Forsyth County Procurement

ADDENDUM #4

RFP 20-78-1620

For: Providing all labor, equipment and materials for the construction of a new Juvenile Justice Center at 875 Lanier 400 Parkway, Cumming, GA 30040. Project includes a multi-phased site development, demolition of existing motel structures and construction of new 62,000 square foot Juvenile Court building.

Sheet No.:
S-1.04

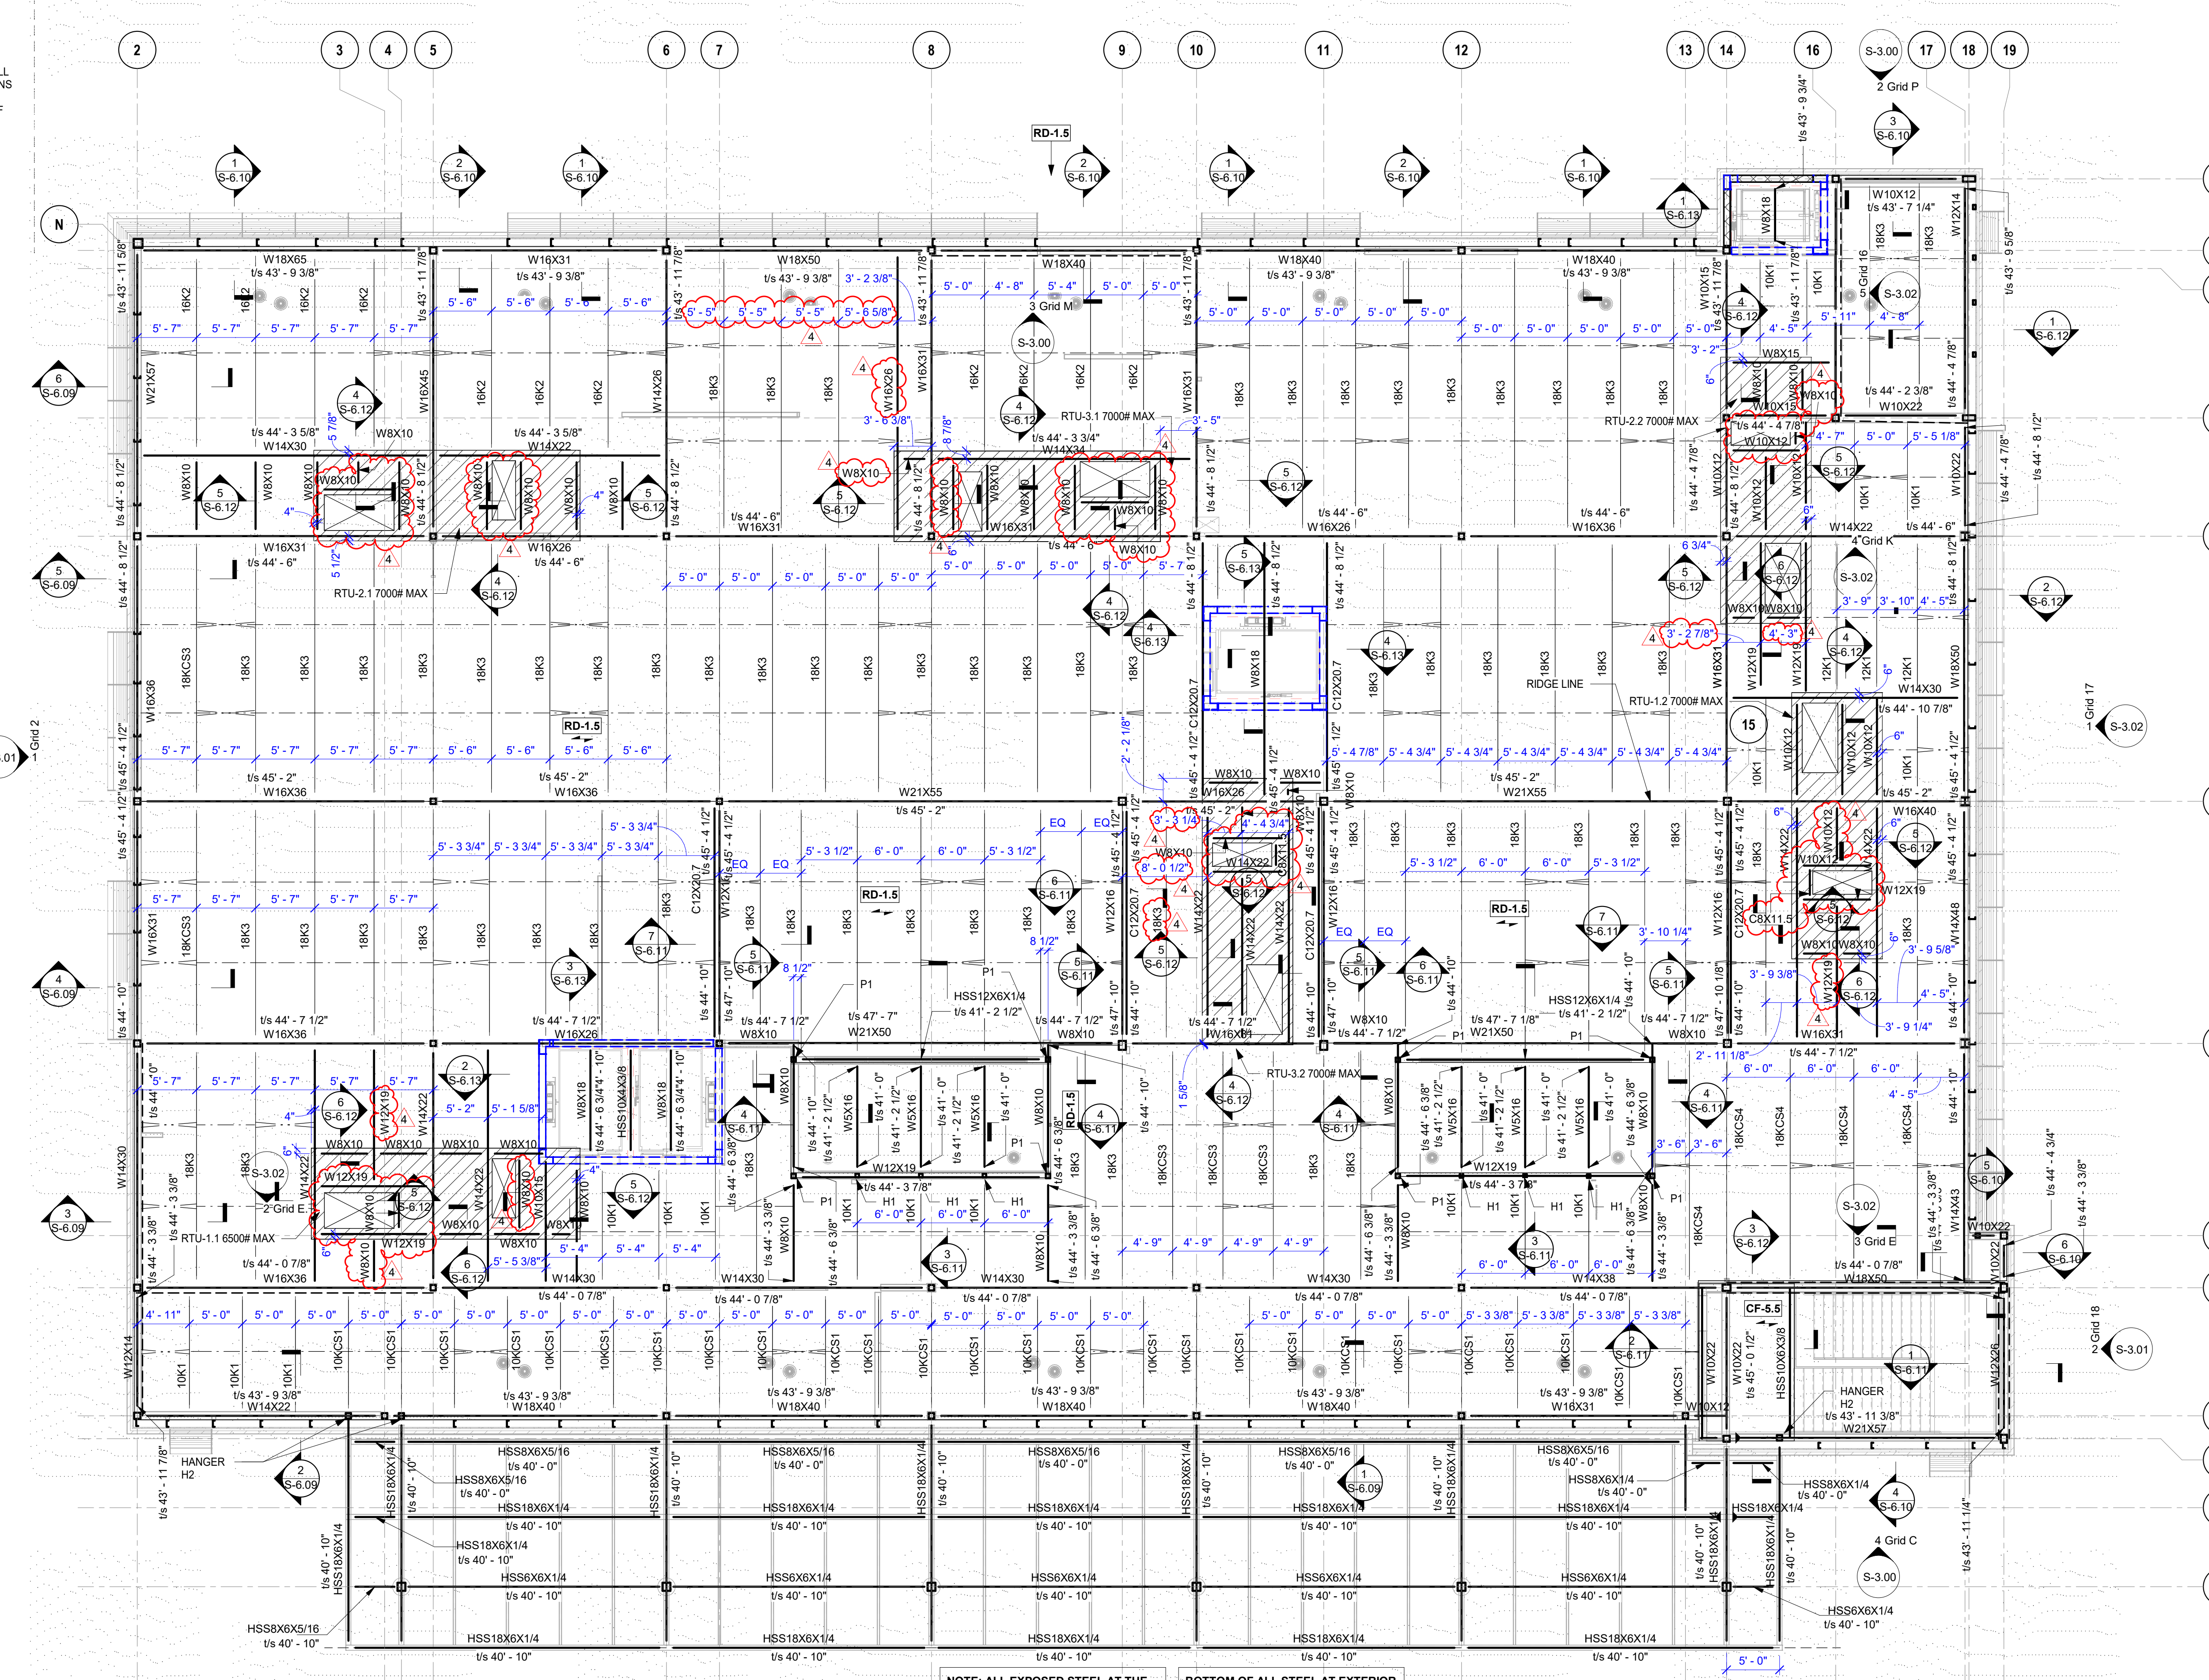
2-1 Sheet S-1.04 ROOF FRAMING PLAN:

1. Roof framing has been modified and adjusted to accommodate Roof Top Unit shifts and return / supply duct locations.
2. Reference sheet S-1.04 ROOF FRAMING PLAN revised under addendum #04 dated 07/07/2020.

1 ROOF PLAN
SCALE: 1/8" = 1'-0"

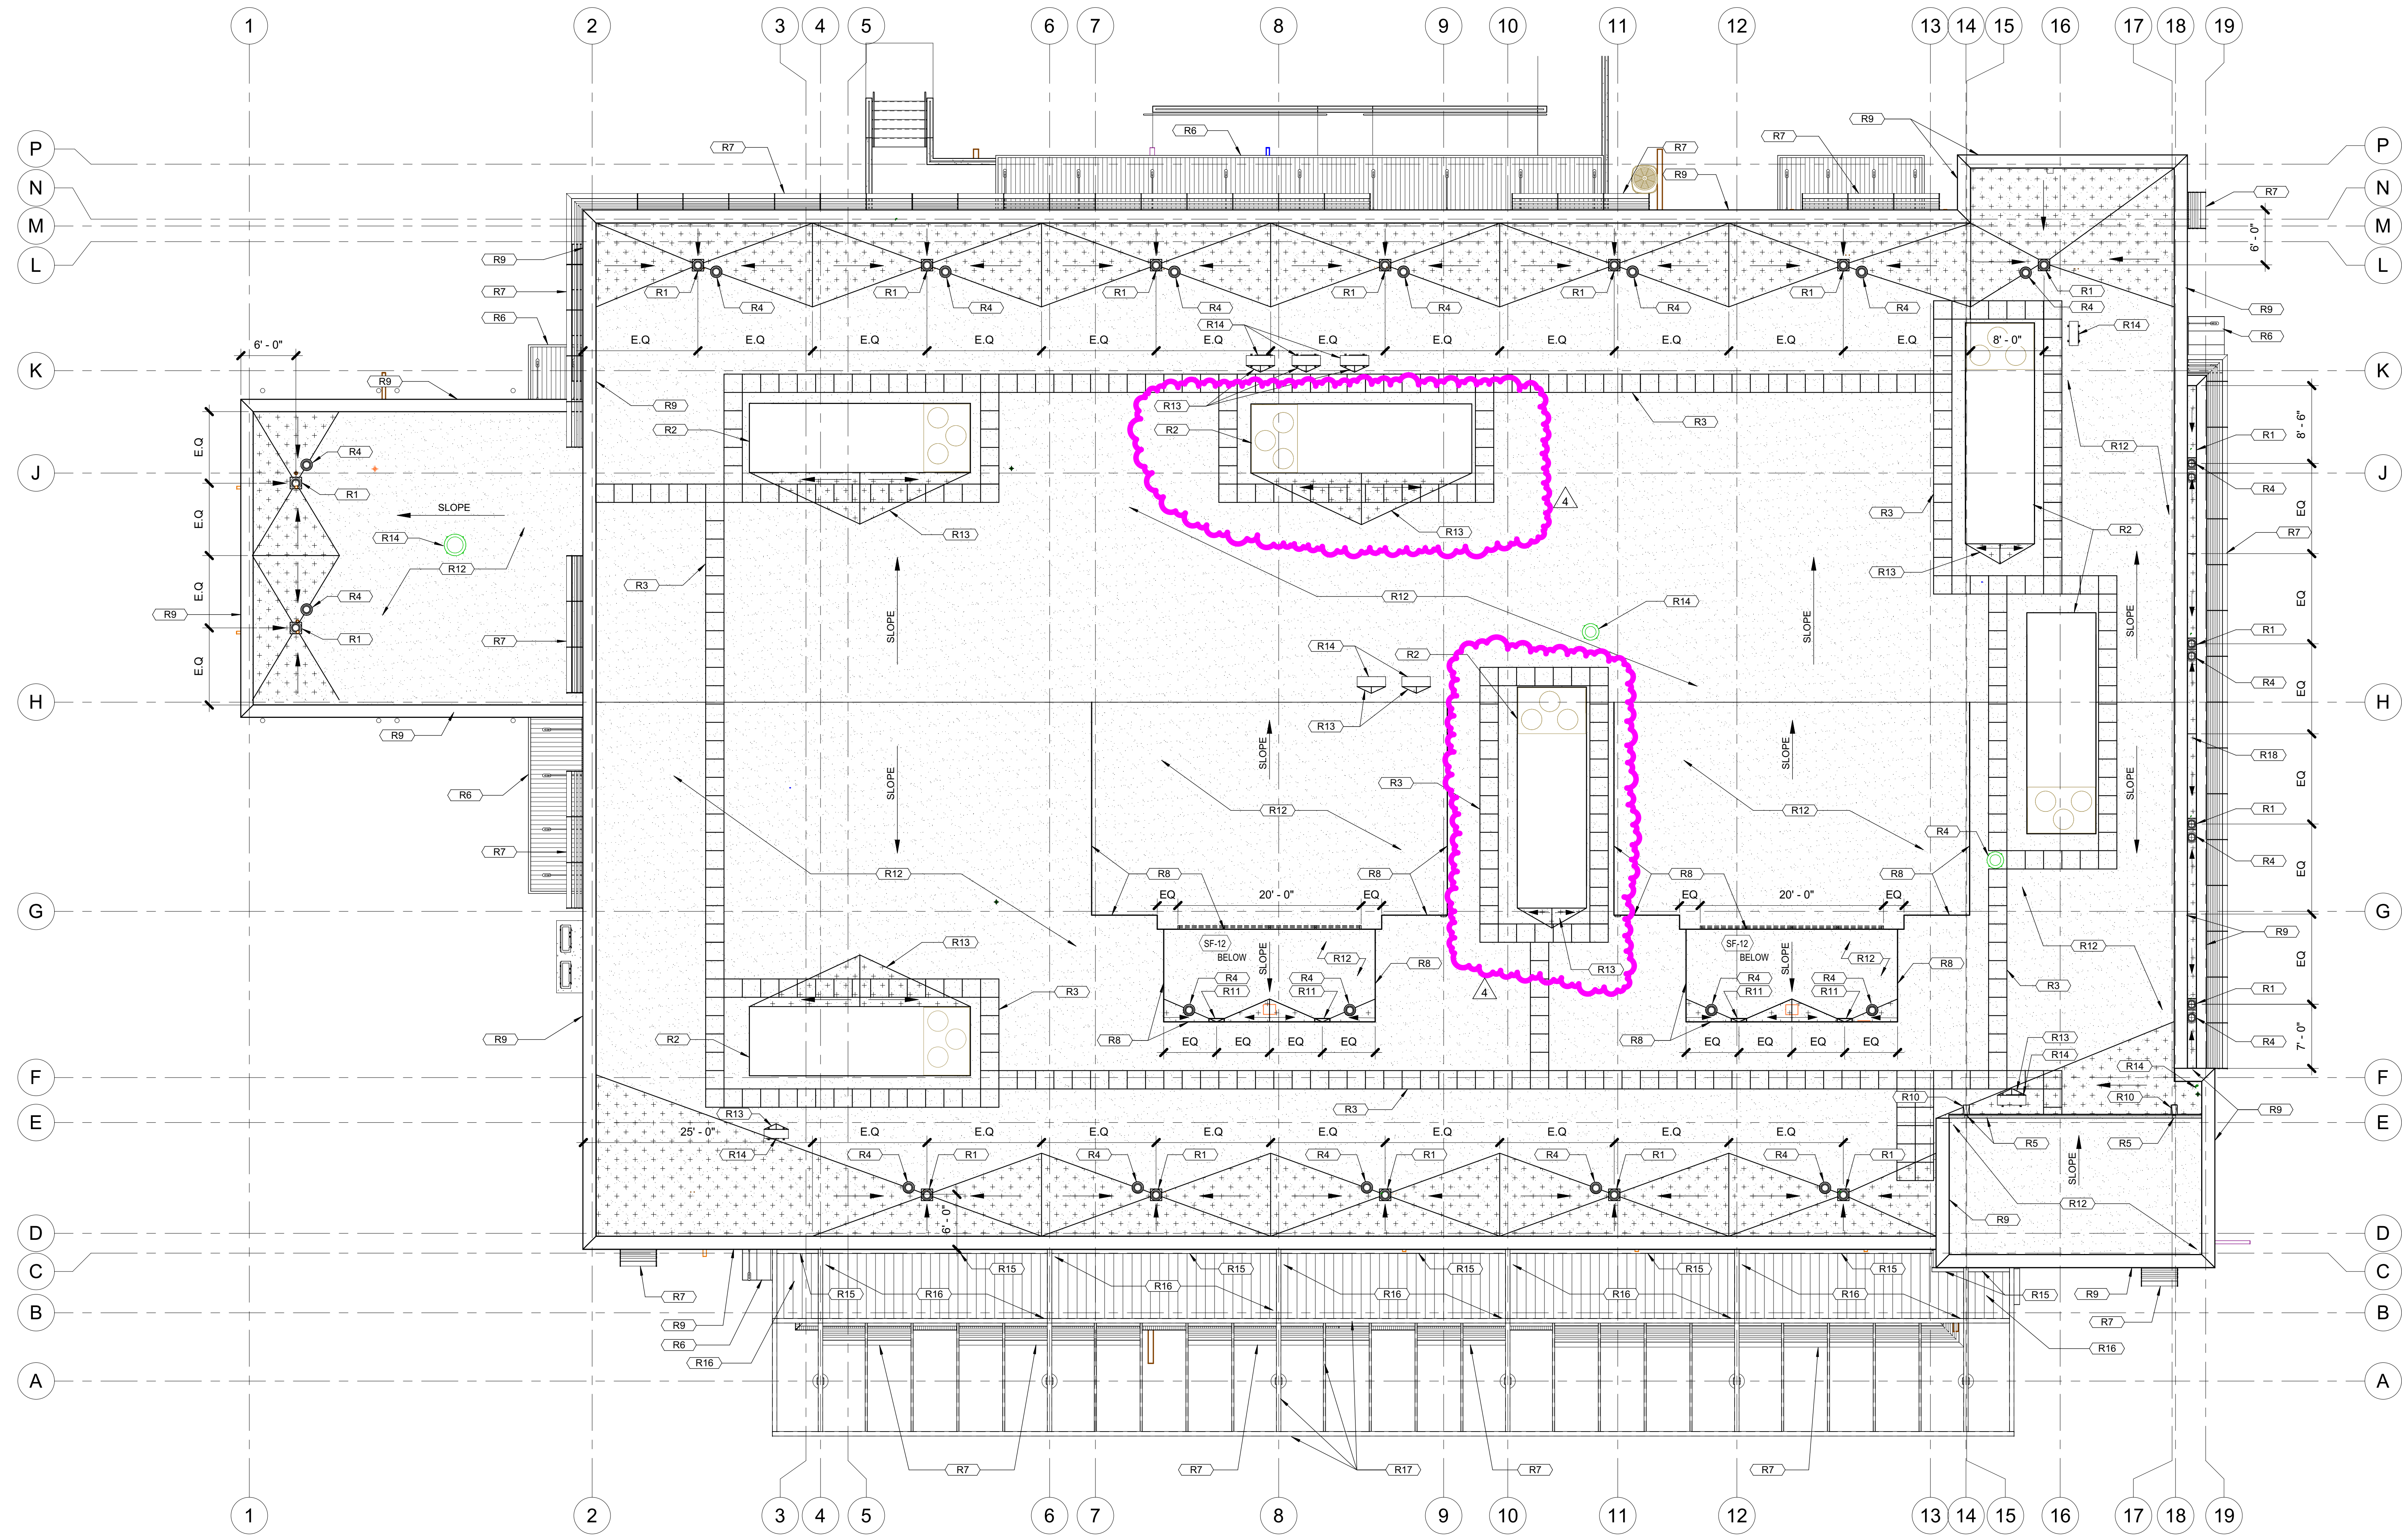
2-3 Sheet A-3.01 ROOF PLAN:

1. Adjusted RTU-2.1 and RTU 3.2, and associated crickets and walkway pads.
2. Reference sheet A-3.01 ROOF PLAN revised under addendum #04 dated 07/07/2020.
